**MEMPHIS AND SHELBY COUNTY OFFICE OF PLANNING AND
DEVELOPMENT
STAFF REPORT**

CASE NUMBER: PD 10-315 **L.U.C.B. MEETING:** November 10, 2010

DEVELOPMENT NAME: Power Center Planned Development

REQUEST: Mixed Use Planned Development (Middle and High School,
Performing Art Center, Residential and Commercial Uses

Concept Plan

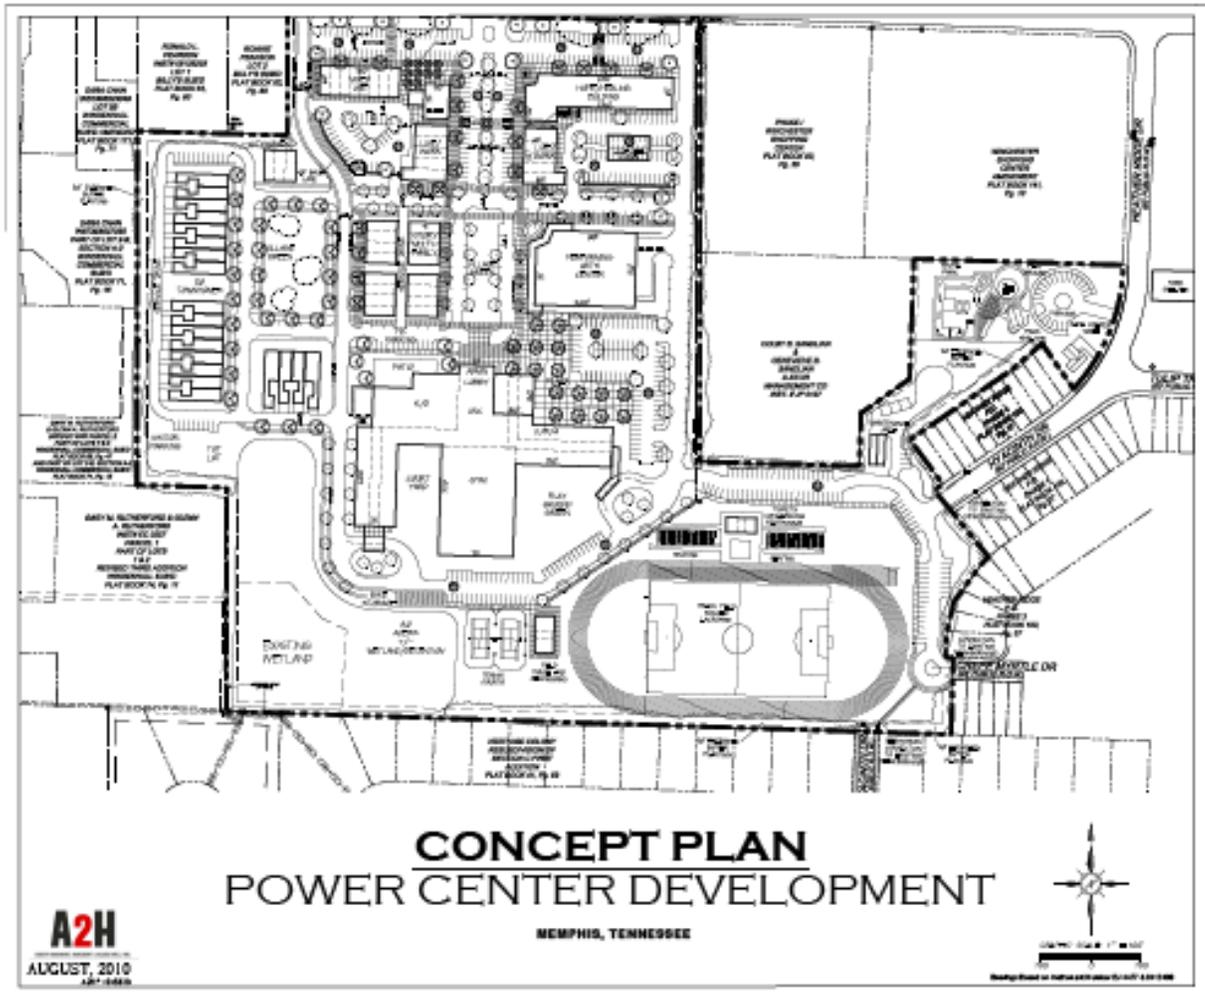
Connectivity - One area of concern for the Planning staff is the exterior connections to the east and south. Both the Unified Development Code in general, and the criteria for reviewing a Sustainable Subdivision in particular stress the need for connections within developments as well as to existing development along the perimeter.

As indicated above, the concept plan shows a private street network that provides vehicular and pedestrian access to the lots in Phases 1 and 3 of the Heather Ridge P.D., (Hyacinth Dr. and Crepe Myrtle Dr.) What is not clear is if these private drives will be gated and under which phase of this development these connections will be made. The conditions on phasing (Conditions – Roman Numeral VII) indicate that the recreation fields will be among the last phases of development. It makes sense that the development of these roads will coincide with the development of the fields. If these points of connection are cut off by a gate, then there will be periods where abutting residents will have to rely on the major road network to access the mixed use market area of this development. On a similar note, if not developed until later phases, this access will not be available.

The staff recommends that gates be limited to the area surrounding the school facility and that the timing of development for these roads coincide with the development of the mixed use market.

Along the south property line, Hyacinth Drive was stubbed into this site. Again, the Unified Development Code calls for extending stubs into new developments. The Concept Plan calls for a pedestrian connection here which will allow abutting residents access to the recreation field which is an important consideration. But here again, would-be customers of the uses included in the Mixed Use Market Area will be required to travel a somewhat circuitous path which ultimately will include the major roads of Mendenhall and Winchester for a trip that could

The staff recommends continuing this connection into the development.

- b. Area 3 is allowed to provide a secured/gated entry subject to # 3. above and the Fire Marshall.
 - c. Gates should be limited to the area immediately surrounding the school facility and shall not prohibit access to the balance of the Planned Development.

6. The north stub of Hyacinth Street at the south property line shall be extended into this development.
7. The development of the private drives that connect to Hyacinth Road and Crepe Myrtle shall coincide with the development of the Mixed Use market.

Internal Street Cross Sections

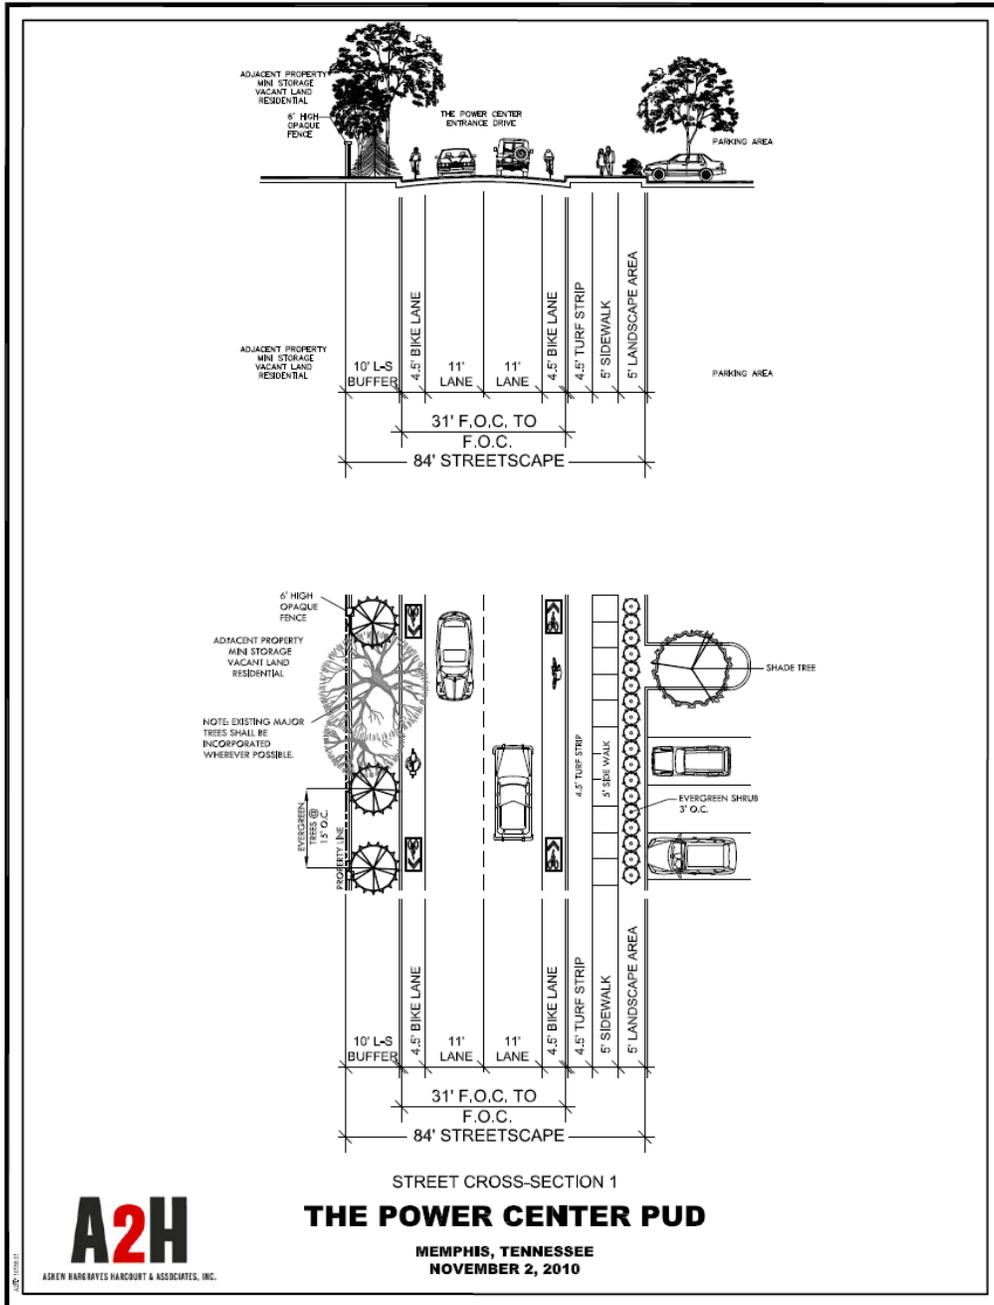
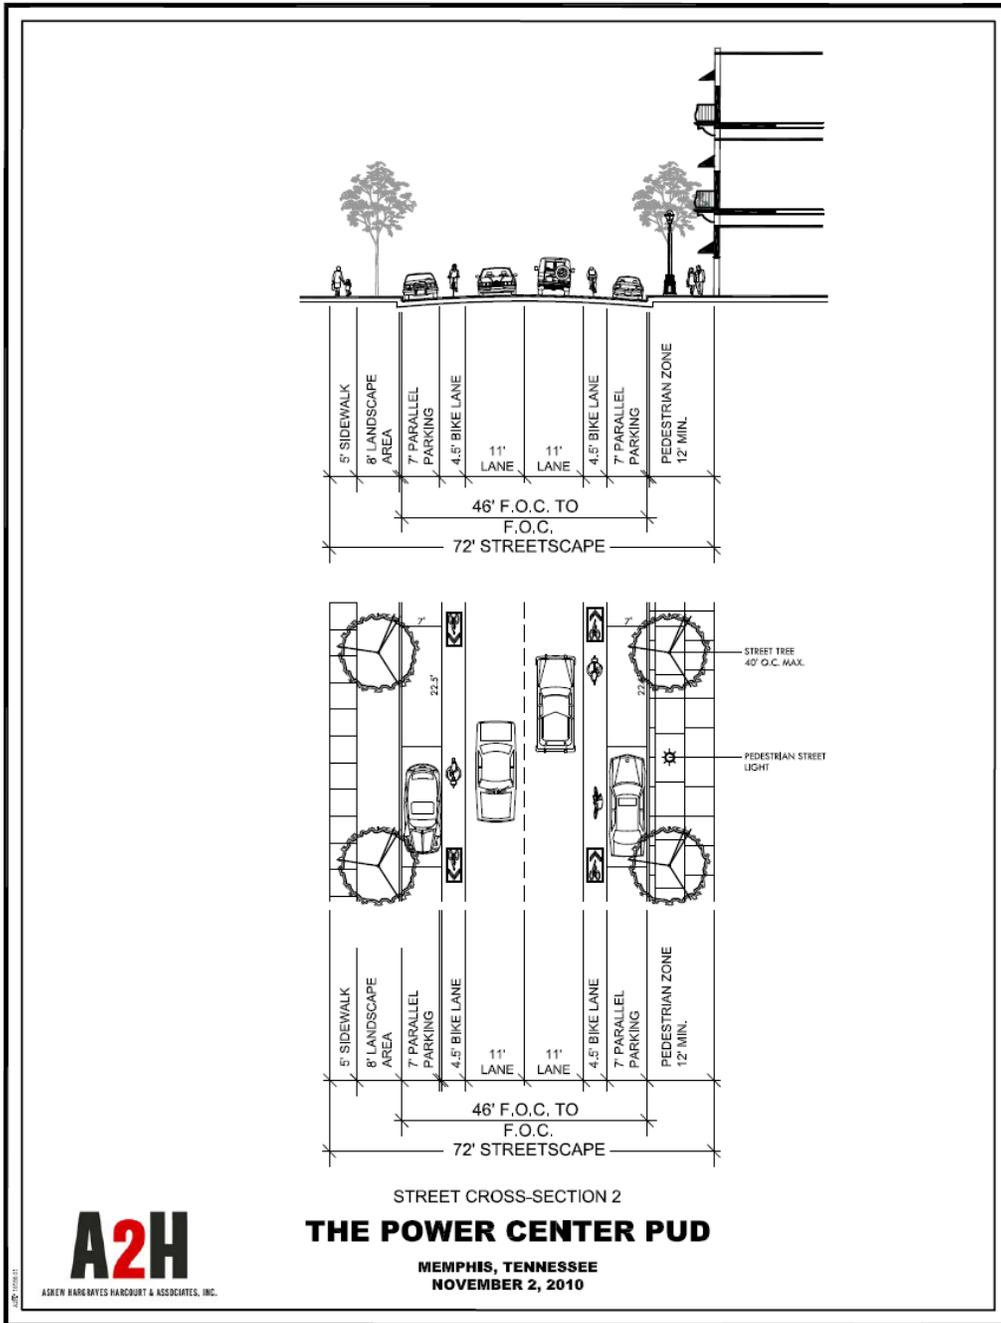
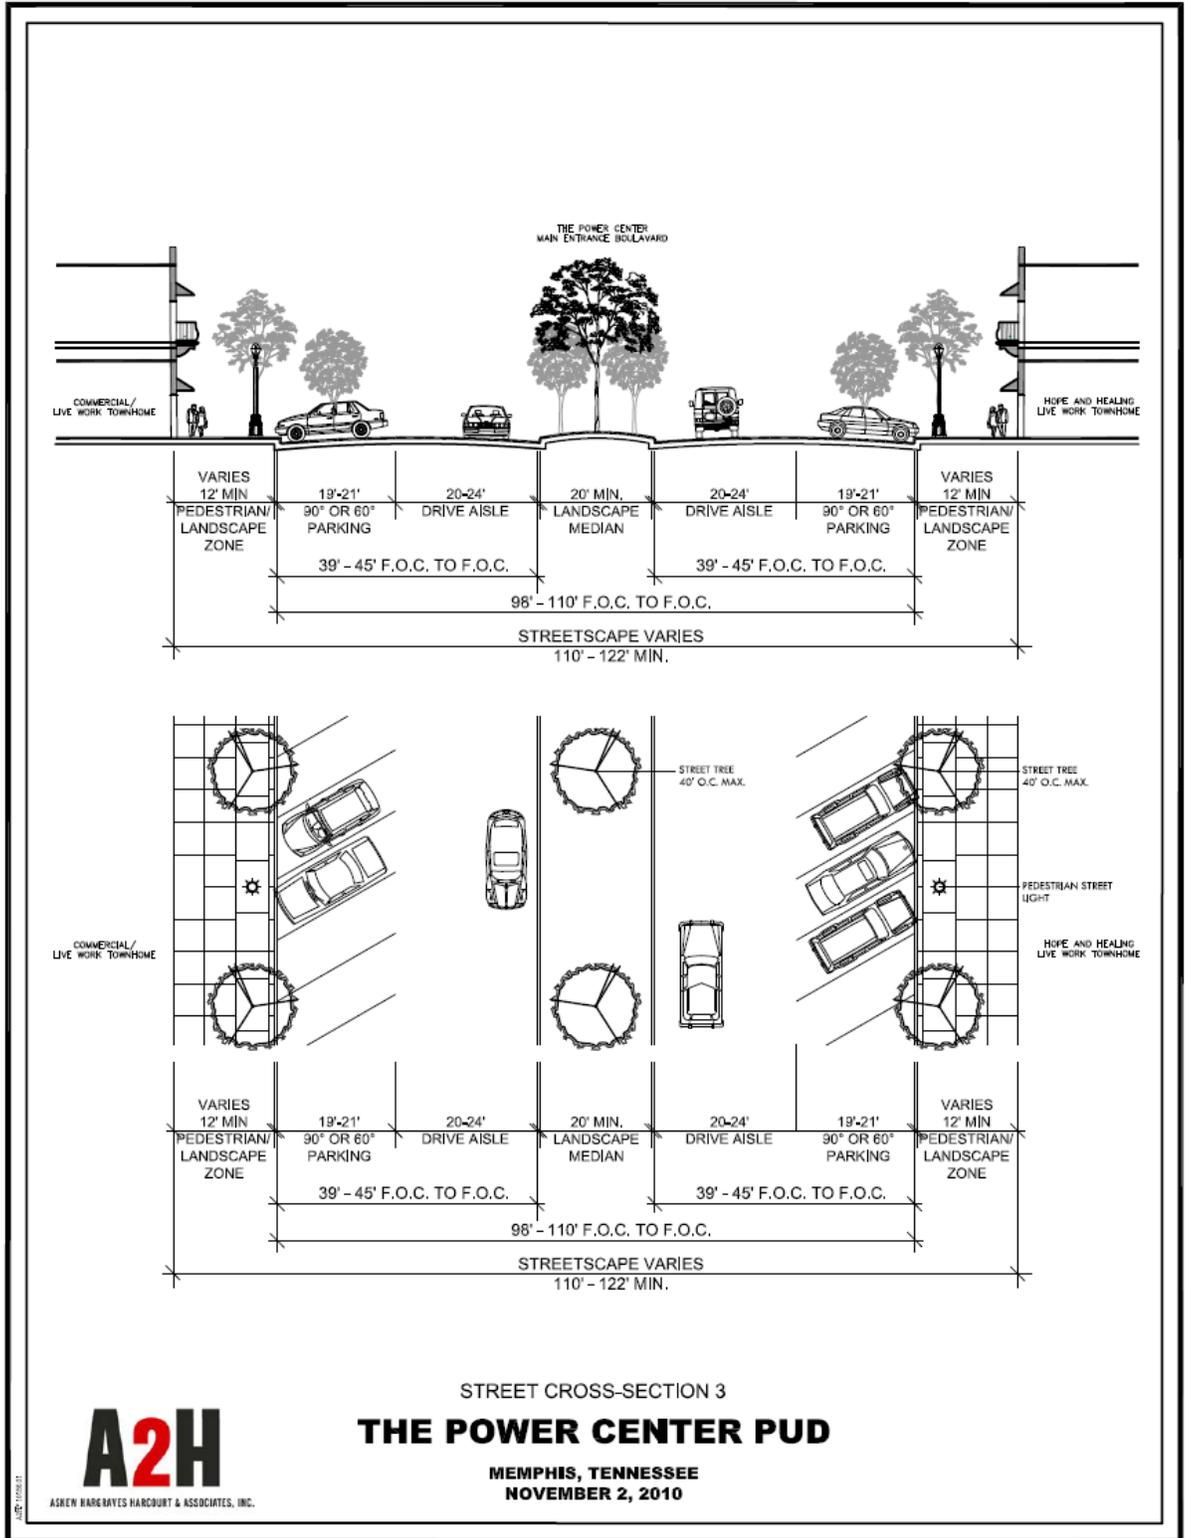
Other Features – The applicant has submitted typical road cross sections that include the median divided, boulevard style main entry and two other cross sections that include the opportunity for bike lanes and on-street parking. The existing developments to the east and south are connected to this development by virtue of a private street network and/or a pedestrian easement.

4. All streets and service drives shall be labeled as "Private". The appropriate street cross-section (as included with the Outline Plan) will be shown on each Final Plat, subject to the review and approval of the OPD.
